Zeus Guardian Strategy and Updates for SC2.5

Notice
Revised April 2017. This bulletin supersedes the previous bulletins, numbers 2013-66 and 2013-66R1 dated June 2013 and December 2014.

Models Covered	Year
Zeus KH Pods	2012-2016

The hydraulic steering manifold for each pod contains three pressure transducers. These steering pressure transducers are identified by letters b, c, and e in the following illustration.

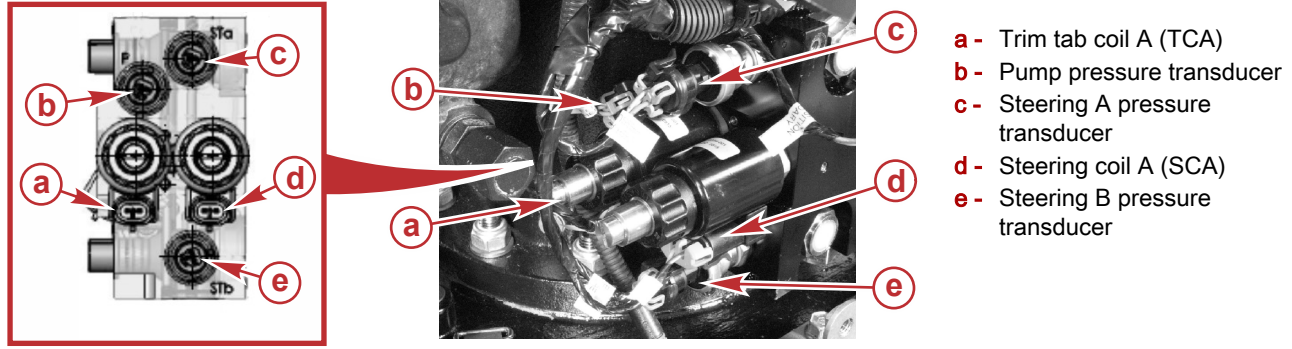
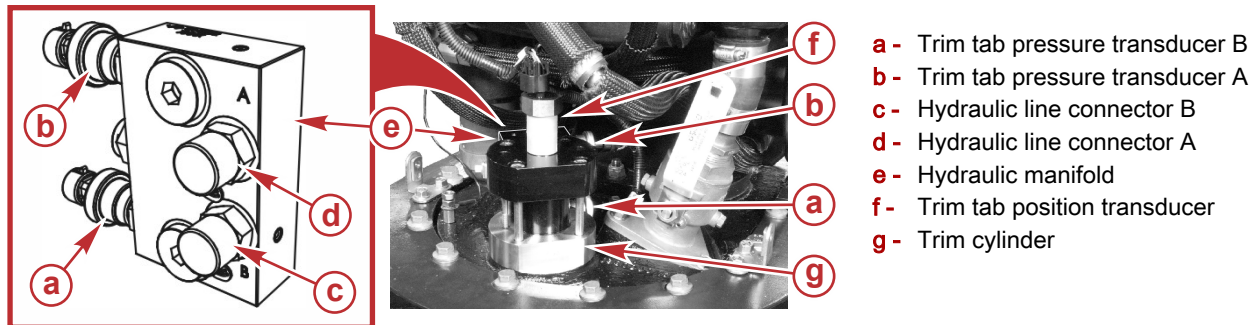
There are a total of five transducers on the steering and trim tab hydraulic systems of each pod. Replace each of the five transducers on each pod.

The hydraulic trim tab manifold for each pod contains two pressure transducers. These trim tab pressure transducers are identified by letters a and b in the following illustration.

Tighten each transducer to the specified torque.

Description	Nm	lb-in.	lb-ft
Hydraulic pressure transducer	25	-	18

Trim tab manifold
a - Decal placement

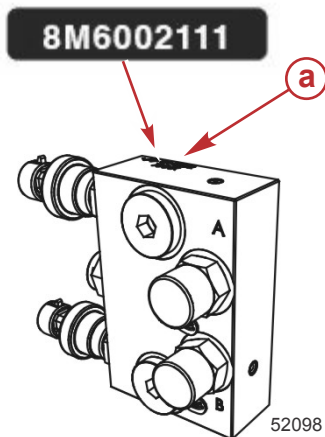
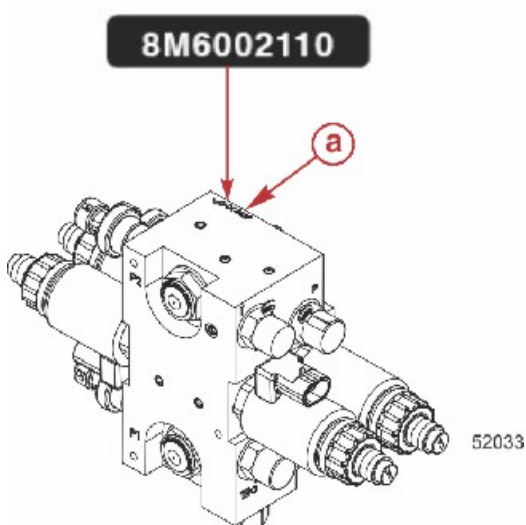
Two labels indicating that the new 3500 psi pressure transducers have been installed are included in the transducer kit. The labels should be installed on both the steering manifold and the trim tab manifold. Refer to the following graphics for the placement of the labels.

IMPORTANT: Ensure that the label mounting surface is clean and free of oil prior to application.
